Didcot Garden Town HIF 1 Scheme

EIA Regulation 25 Response (April 2023)

Oxfordshire County Council

Figure 1: Extracts from drawings S3/HAN/14/26 Rev B and Landscape GA Sheet 12

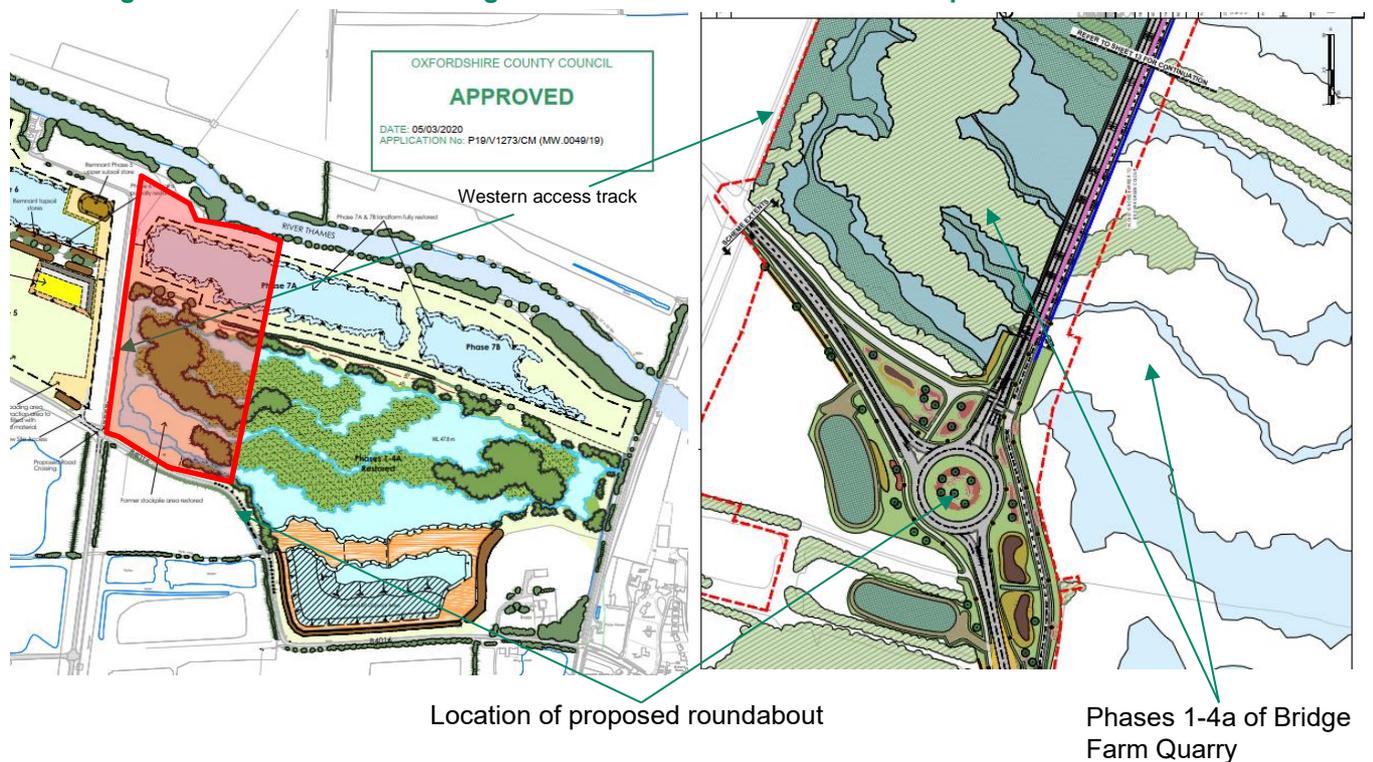
“Further information is required to show the potential impact of the Scheme on the restoration of Sutton Courtenay Landfill Site and Bridge Farm Quarry. Drawings should be provided which illustrate how the approved restoration schemes could be revised to include the Scheme. Information should also be provided to clarify the roles and responsibilities for delivering the revised restoration schemes, and measures to protect against the potential that revised restoration schemes do not secure planning permission or are not capable of delivery.”

- 11.3 Figure 1 below provides annotations across Bridge Farm Quarry drawing S3/HAN/14/26 Rev B and Landscape GA Sheet 12. The red area shows the approximate location of where the Scheme overlaps within the Bridge Farm Quarry restoration area.

11.5 In terms of delivering the Bridge Farm Quarry restoration area, all of the restoration area outside of the Scheme's site boundary will be delivered by Hanson under application reference MW.0049/19. Where the Scheme overlaps the approved Bridge Farm Quarry restoration area, the Scheme seeks to maintain the proposed habitats which were approved as part of the Bridge Farm Quarry Restoration area but factors in the new interventions to deliver the River Thames Crossing. This can be seen through comparing the extracts from MW.0049/19 and Landscape GA Sheets 12 and 13 in Figures 1 and 2.

Figure 2: Extract from drawing S3/HAN/14/26 Rev B and Landscape GA Sheet 13

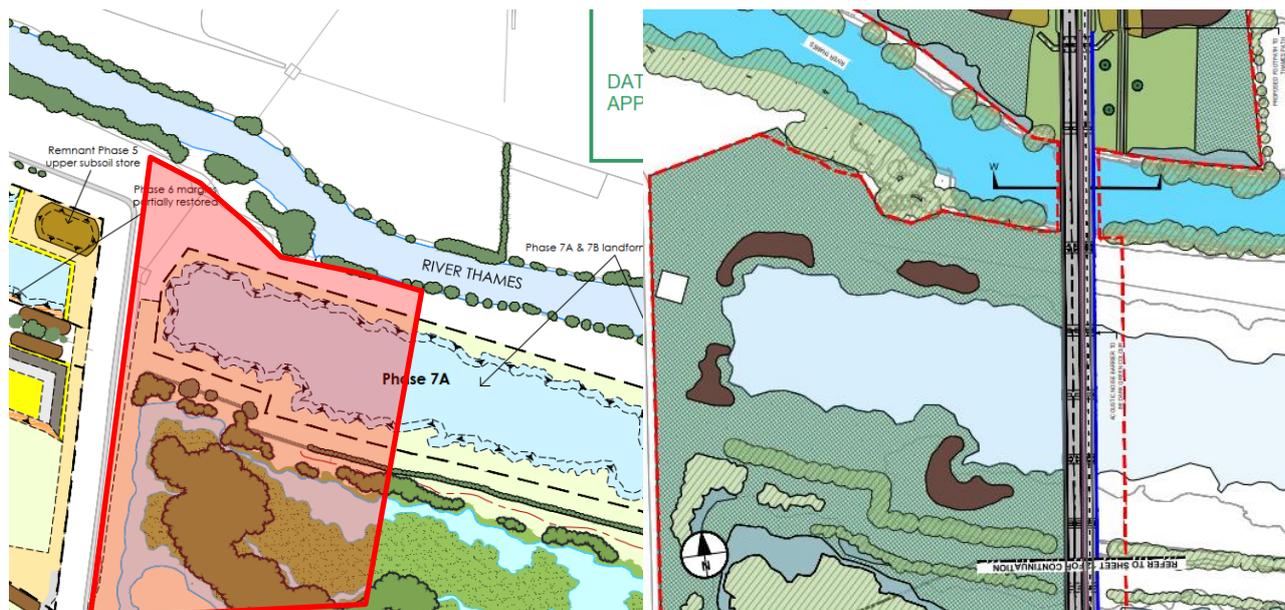
- 11.4 Figure 2 below provides an extract from drawing S3/HAN/14/26 Rev B and Landscape GA Sheet 13, with red area showing the approximate location of the Scheme within the Bridge Farm Quarry Restoration area.
